ADDENDUM NO. 1
To Drawings and Specifications for
Elevator Modernization for
Carver Educational Services Center
Montgomery County Public Schools
07 January 2020

- Revised Sheet E1.1, EXISTING/DEMOLITION & PROPOSED FLOOR PLANS, dated 01/07/2020

E1.1

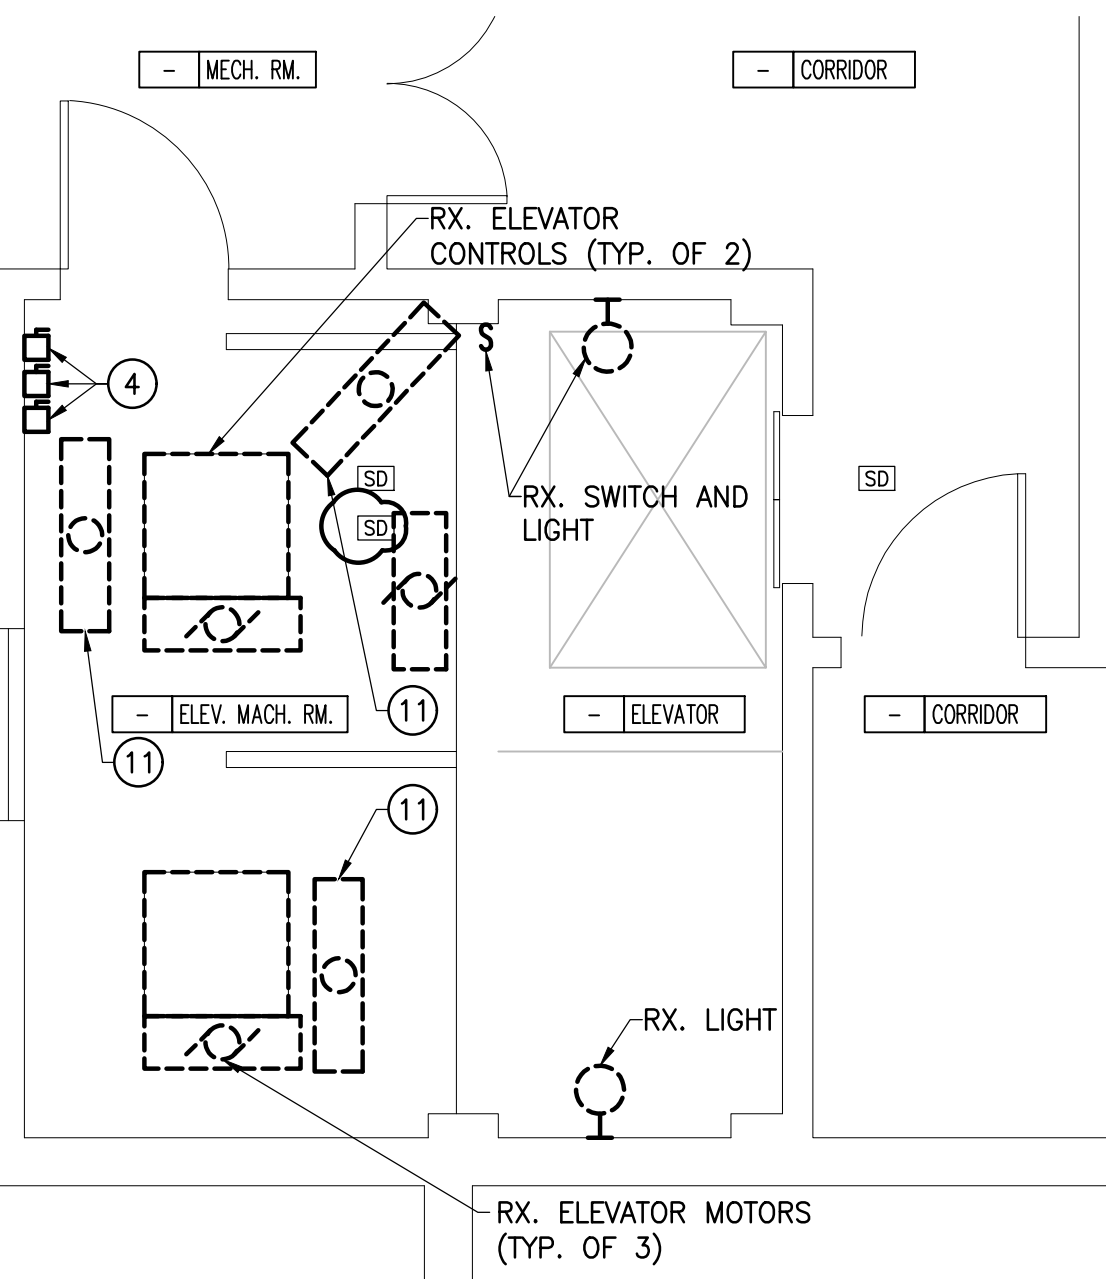
- RFI #01 Is this project subject to prevailing wage/Davis Bacon requirements? If so, please include within the bid documents.
Response: MCPS is to respond.
- RFI #02 Page E1.1 of the drawings shows existing heat detectors within the machine room and elevator shafts. These devices are not existing per field verification. Please advise.
Response: Heat detectors indicated as "existing" can be disregarded, they do not exist.

Response: No sprinkler work is required and shunt trip devices can be removed.
- RFI #04 Adequate elevator machine room lighting is a requirement, but new machine room lighting is not shown. Please advise.

Response: See attached for reissued sheet E1.1, indicating new lighting within the elevator machine room.
- RFI #05 A duplex GFCI receptacle is required within the elevator machine room but is not shown. Please advise.

Response: See attached for reissued sheet E1.1, indicating the receptacle location.
- RFI #06 The existing MDP as shown on page E0.1 of the drawings appears to operate on emergency generator power. Please confirm that the intent is to add these two elevators to the emergency power. If so, all elevator related circuits must also be moved to emergency power to meet code requirements. Please advise how to proceed.

Response: See attached for reissued sheet E1.1, indicating Panelboard B will be used for 120v connections.
- RFI #07 There are no relay modules for the fireman's flashing hat signal within the elevator machine room. This is a code requirement but is not shown. Please advise.

- RFI #15 They show existing machine room lights getting demolished but nothing going back?
Response: See attached for reissued sheet E1.1, indicating new lighting within the elevator machine room.

REVISE The lights in the elevator pit to emergency type as indicated on reissued sheet.

REVISE Drawing Notes 4, 5, 7, and 8, as indicated.

REVISE Heat detector in “Elev. Mach. Rm.” To “SD”

DELETE The heat detectors shown in the elevator shafts.

ADD Drawing Notes 11 and 12, as indicated.

ADD Four emergency lights in “Elev. Mach. Rm.”

ADD GFCI outlet in “Elev. Mach. Rm.” as indicated.
